ADDENDUM 1 (PENDING DSA APPROVAL)

PROJECT: **Santa Ana College**
 Science Center

DATE: 8/23/2017

DSA File No.: 30-C2
DSA Applications No.: 04-115788
HGA Commission No.: 3584-001-00

ENTRY CANOPY FRAMING PLAN

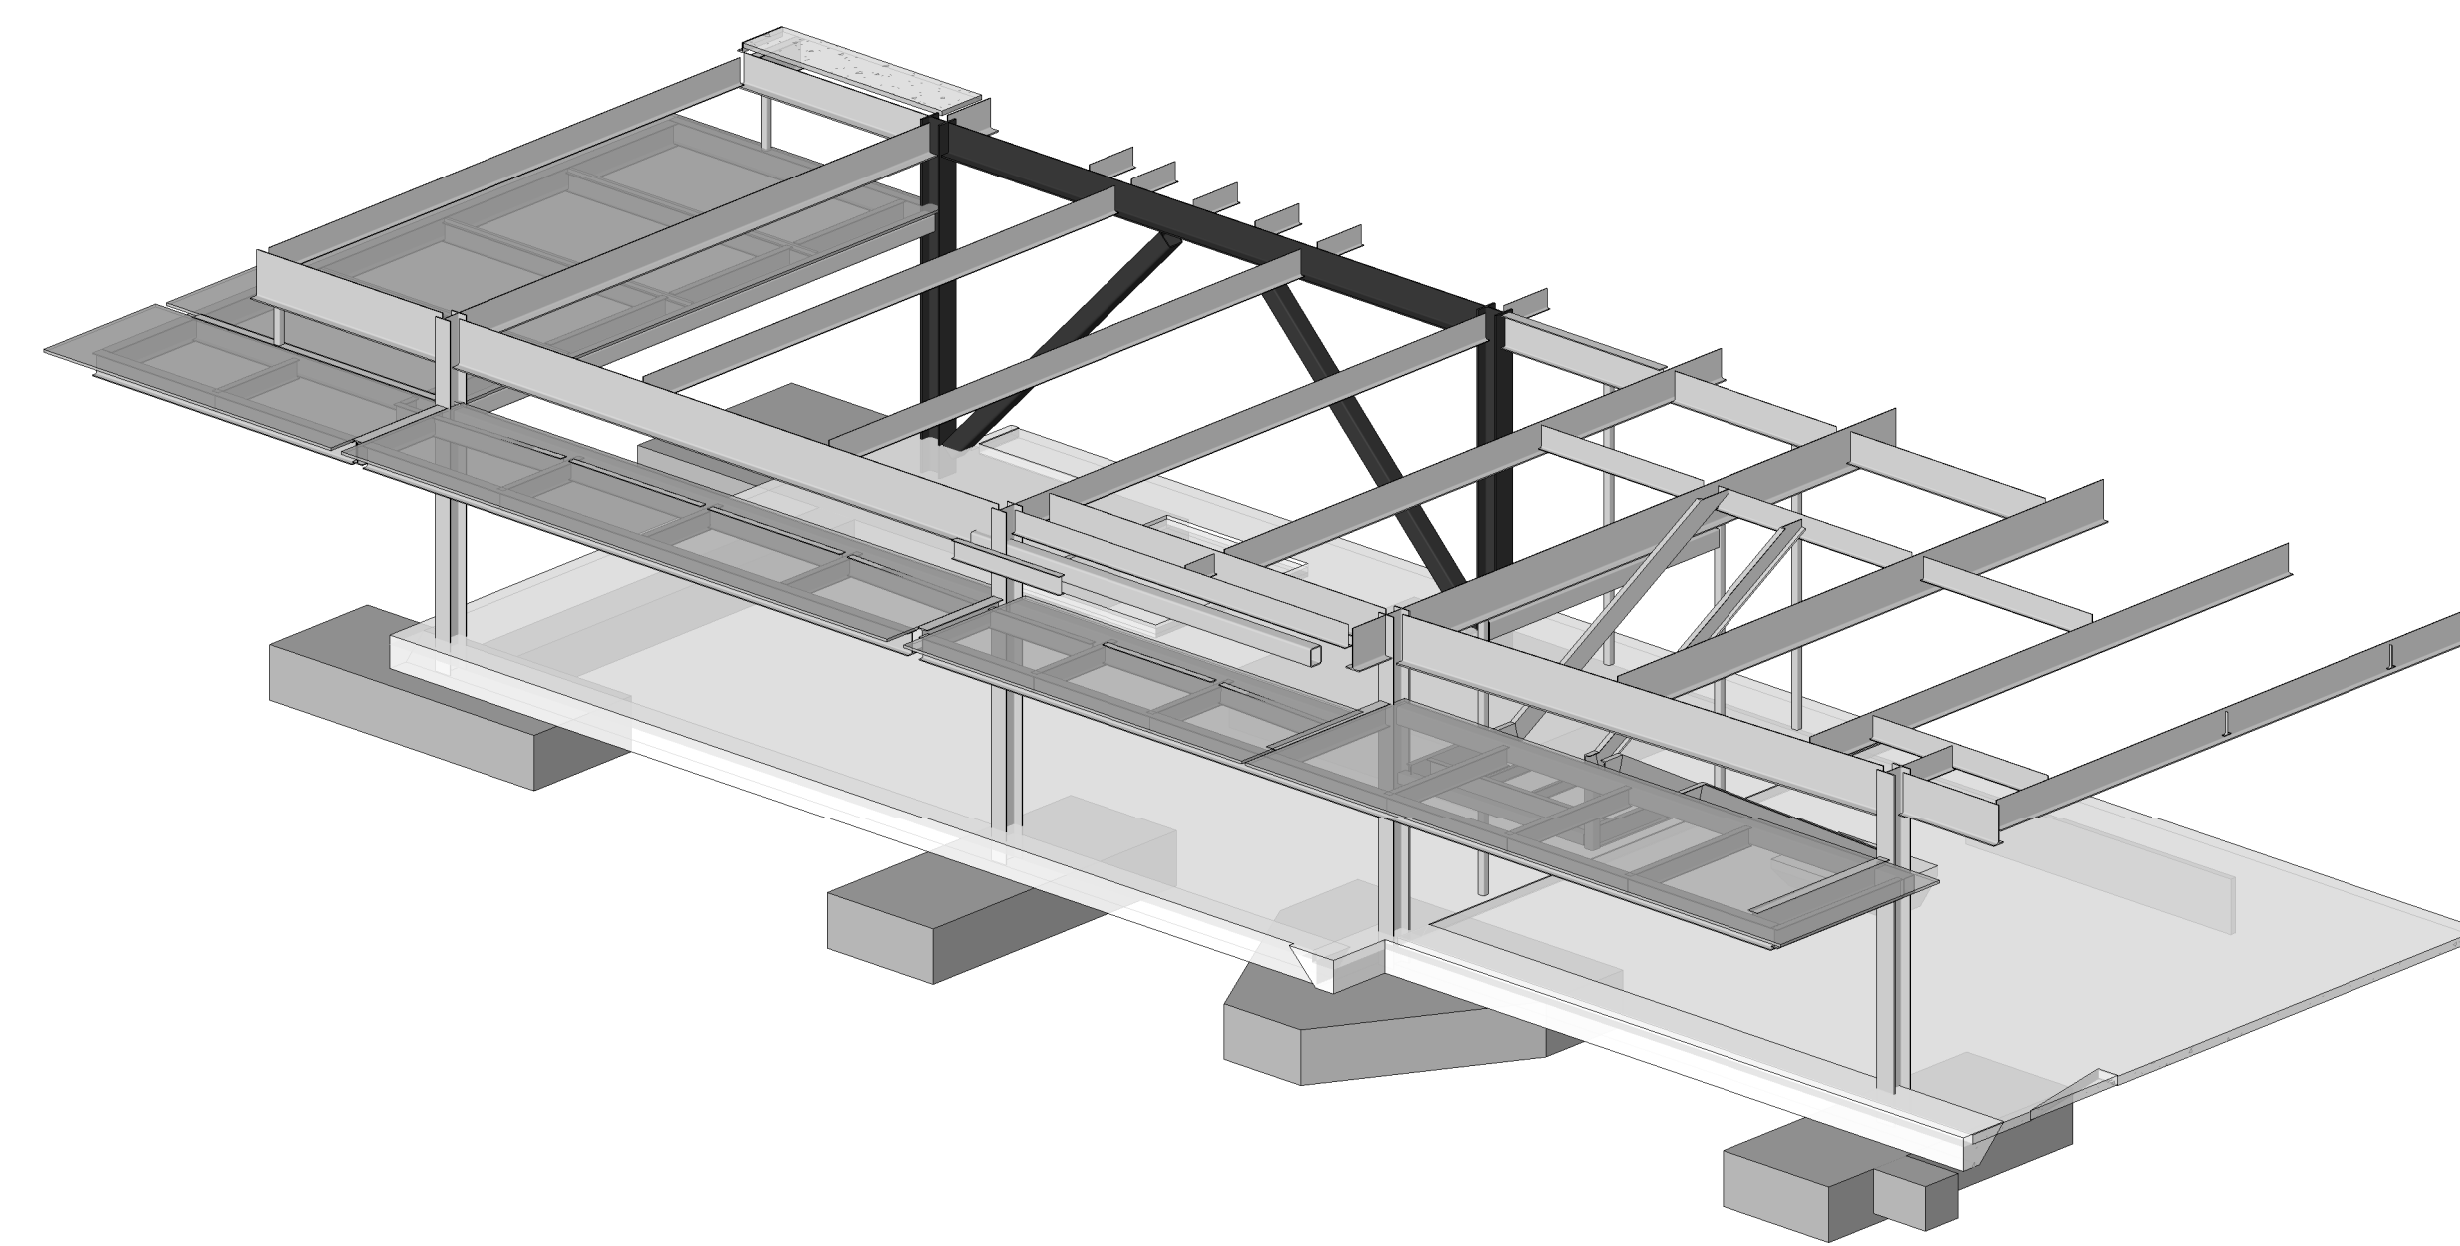
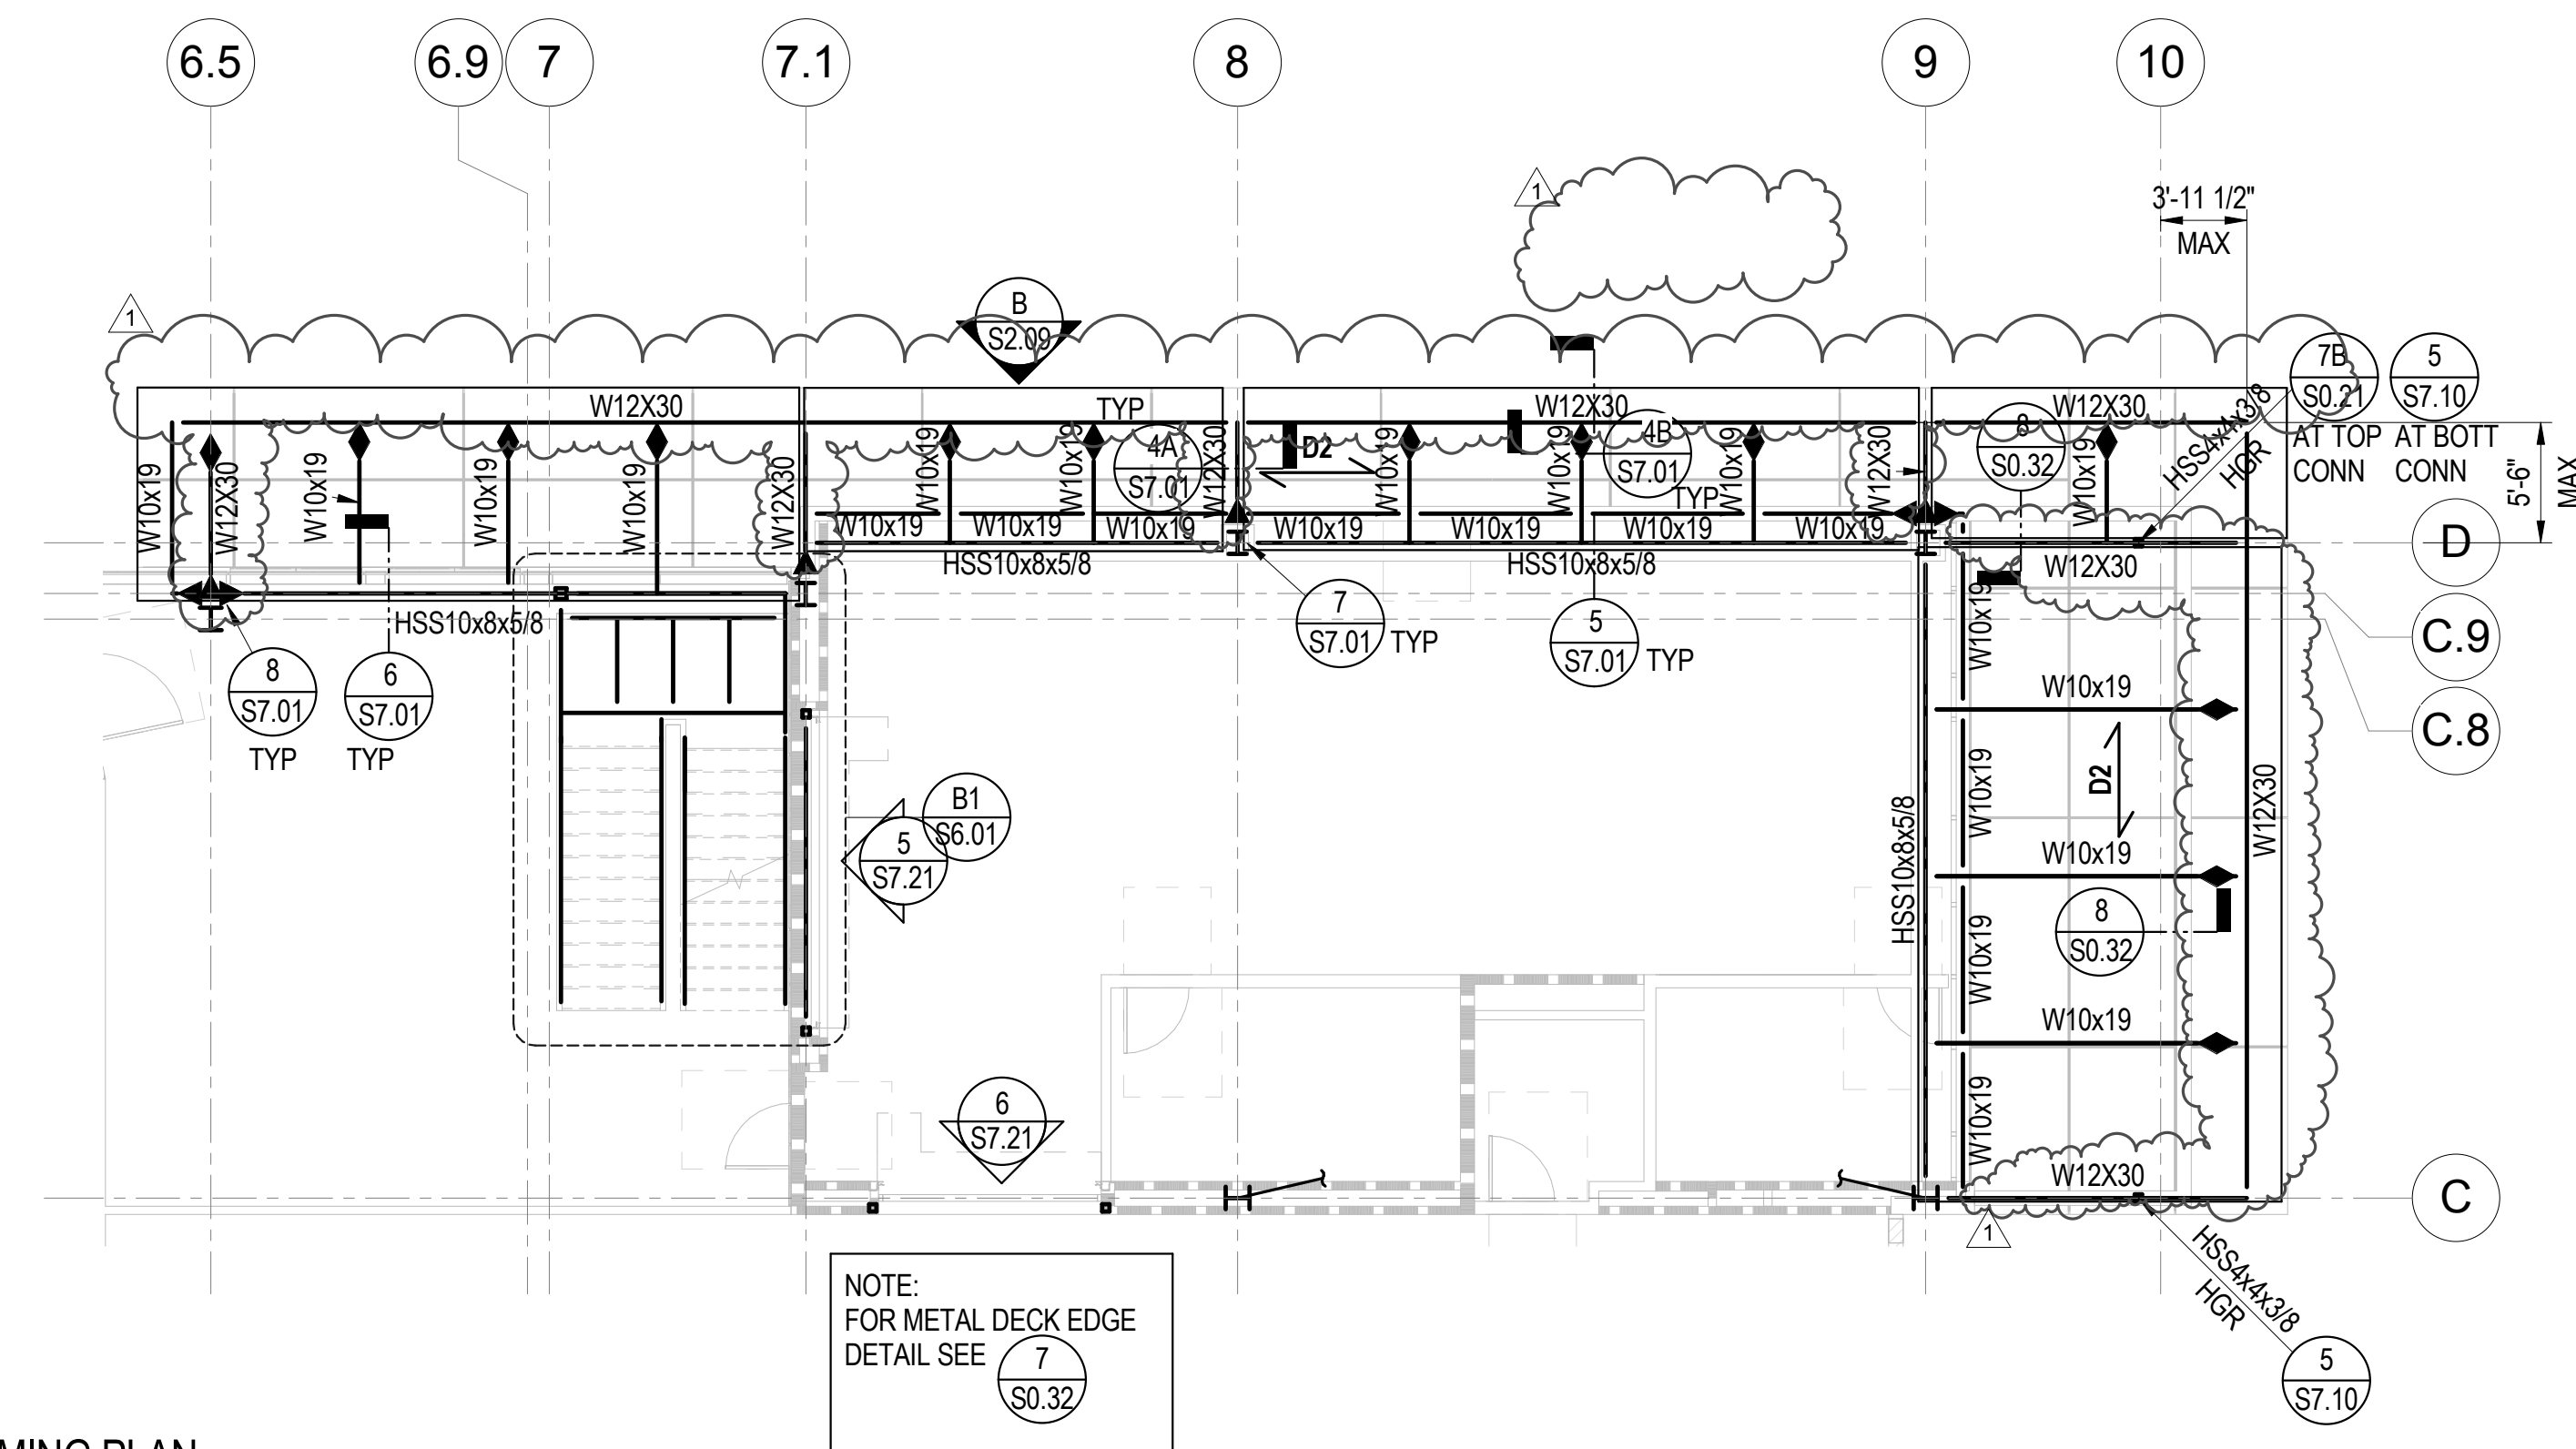
- Extent of the entry canopy shortened by 5'-0"
- A few member sizes were updated based on the revised calculations.
- Angle on top of WF beam has been removed.

S8.13

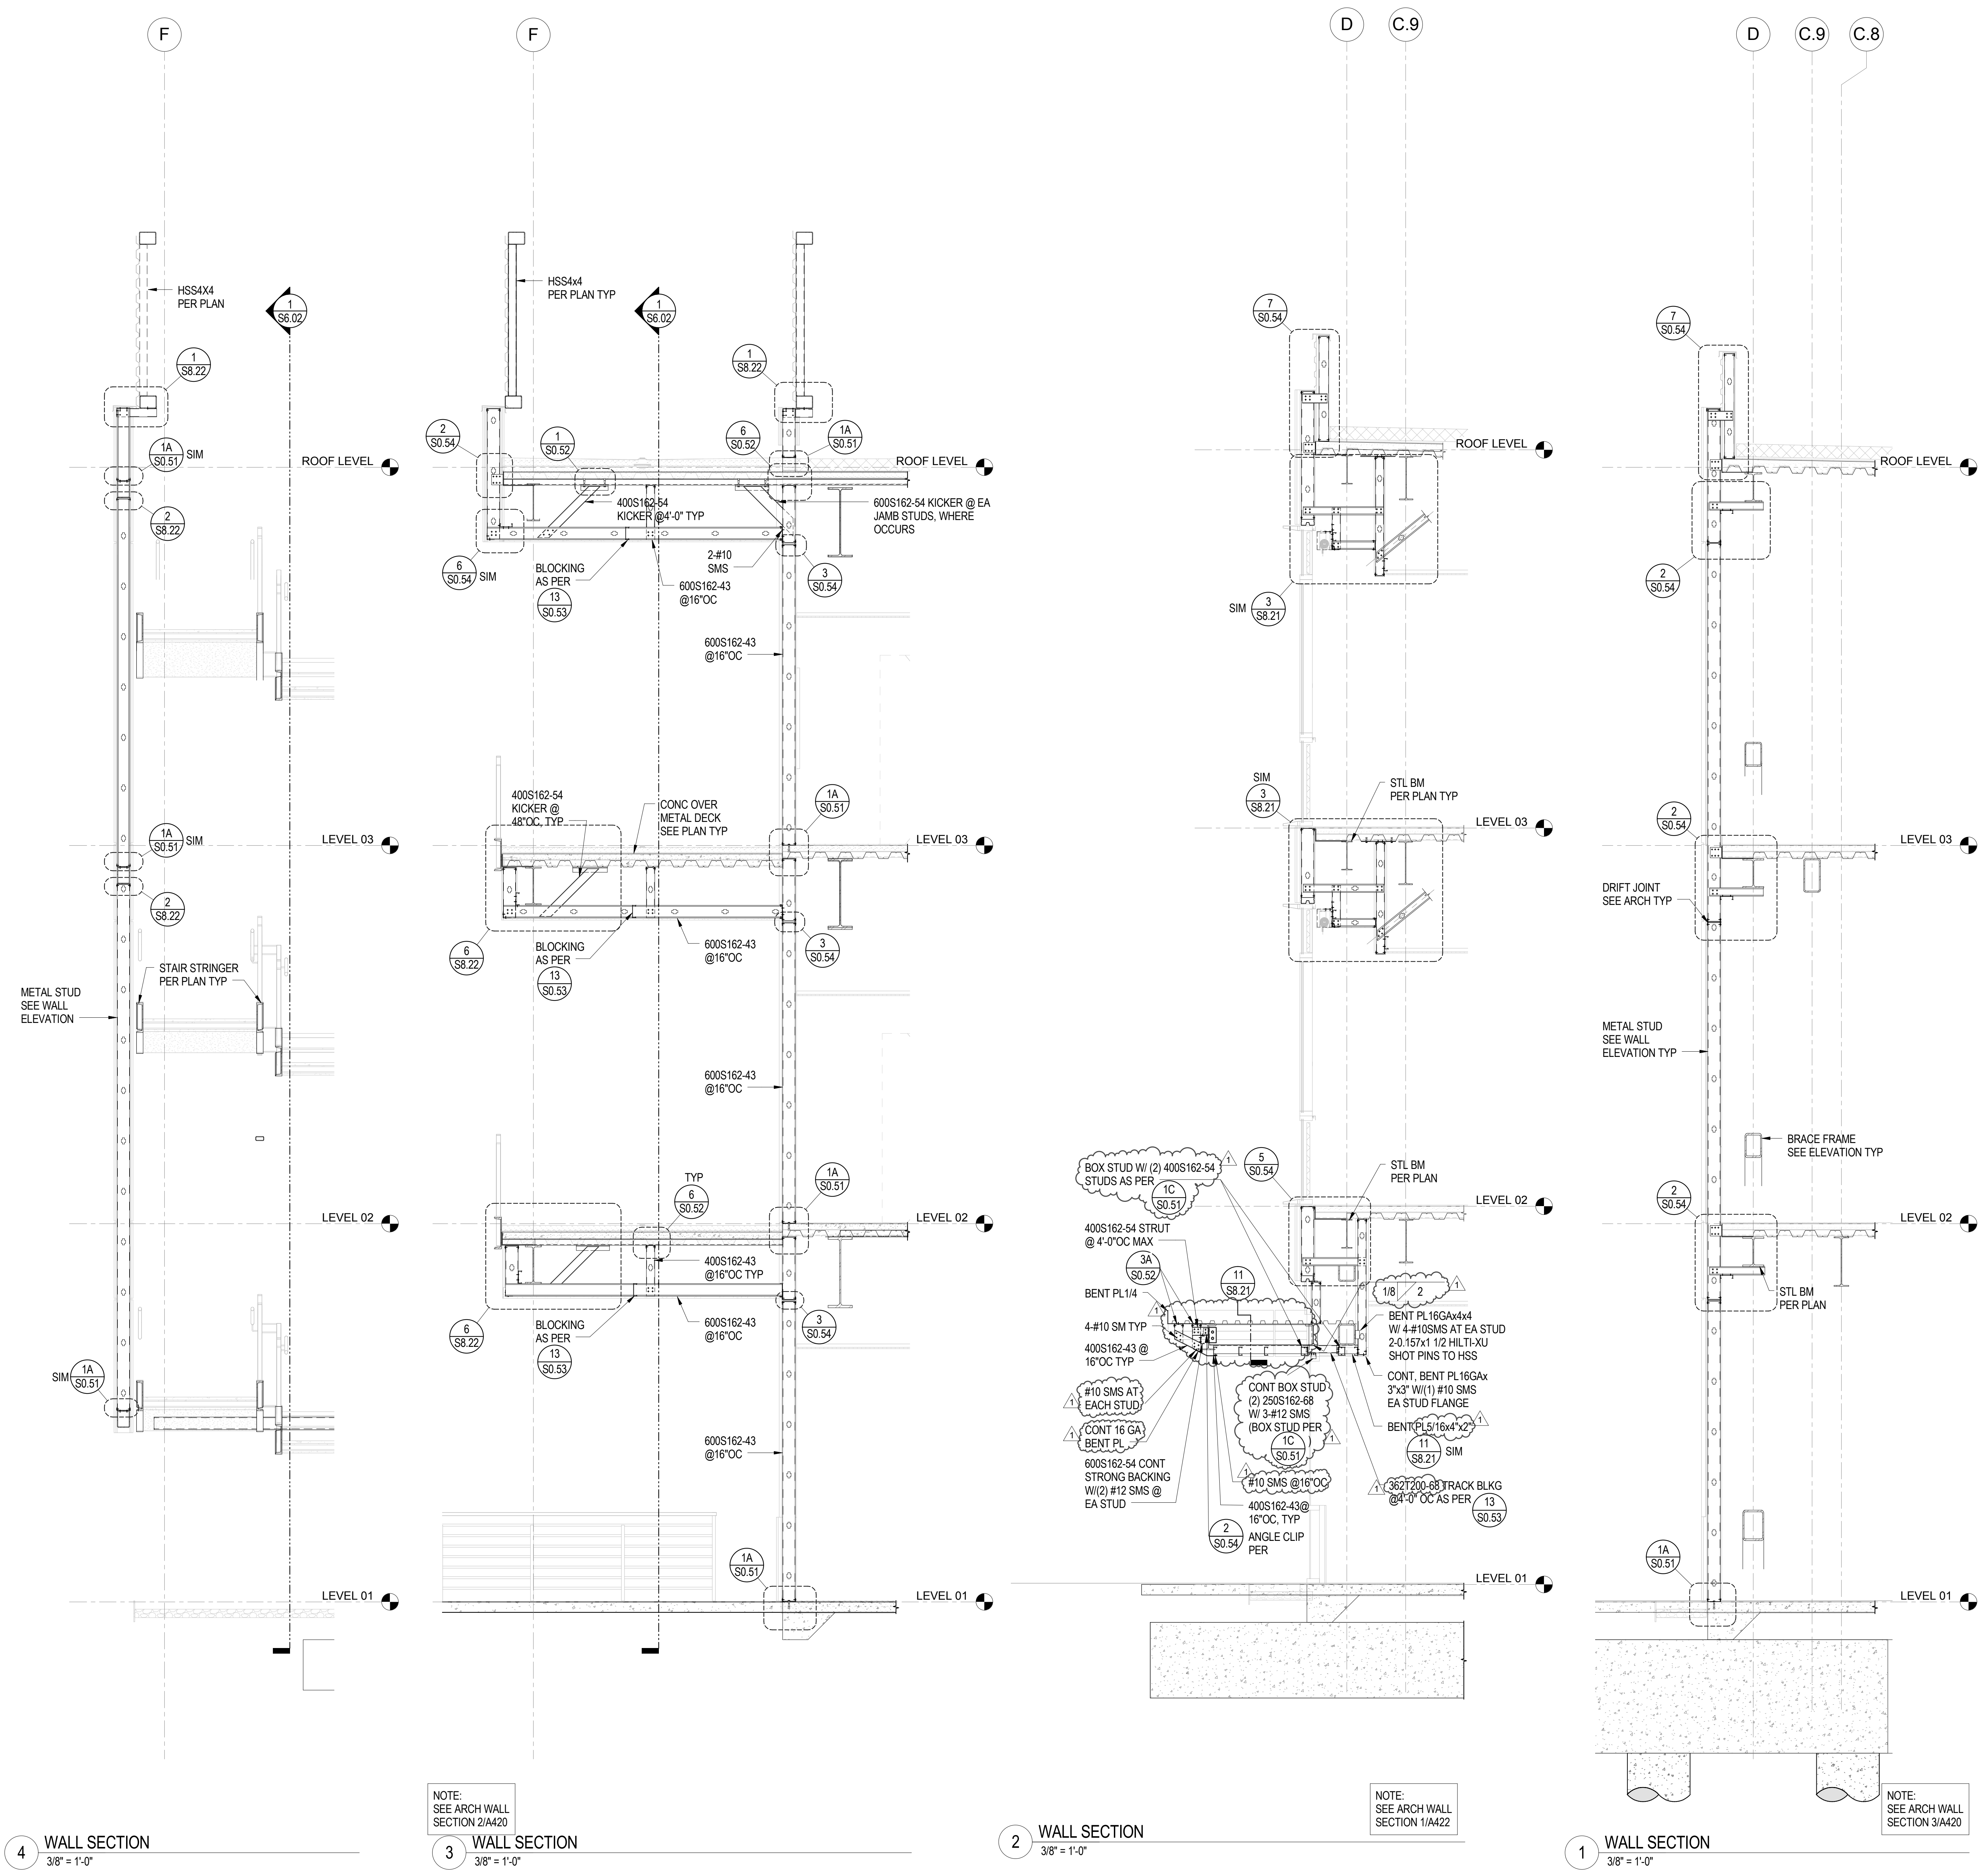
- Detail 2 has been updated based on the revised canopy extent. Additional clarifications provided.
